## Product Change Notice (PCN)

PCN Number: PCN-045-6174R-01

Product(s) Affected: PJ-040D

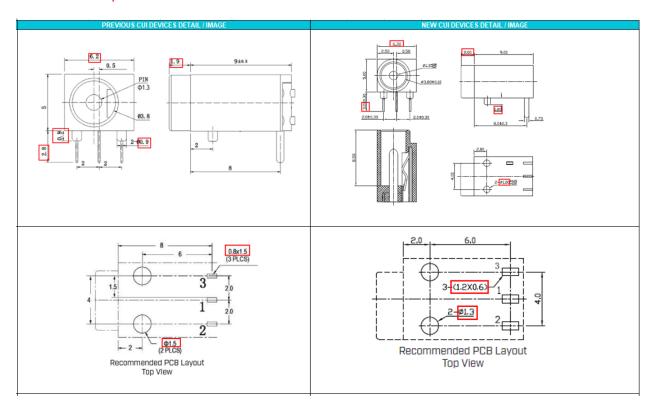
Description of Change: New Factory Location. Product re-engineered for improved manufacturability and production yield. See image below for reference and check CUI Devices website for updated drawing. Cosmetic differences may be visible and not affect the form fit and function of the product.

TAIL / IMAGE		NEW CUI DEVICES DETAIL )	IMAGE
DESCRIPTION	MATERIAL	PLATING/COLOR	DESCRIPTION	MATERIAL	PLATING/COLOR
center pin	brass	silver	center pin	brass	silver
terminal 1	brass t=0.25	silver	terminal 1	brass t=0.25	silver
terminal 2	brass :=0.25	silver	terminal 2	SUS301 t=0.25	silver
terminal 3	brass t=0.25	silver	terminal 3	brass t=0.25	silver
cover	PBT (UL94V-0)	black	housing	PA66 UL94V-0)	black
housing	PBT (UL94V-0)	black			
Ø3.5 ø1.35 MATING PLUG Jack Insertion Depth: 8.0 mm			Ø1.35  MATING PLUG  Jack Insertion Depth: 8.5 mm
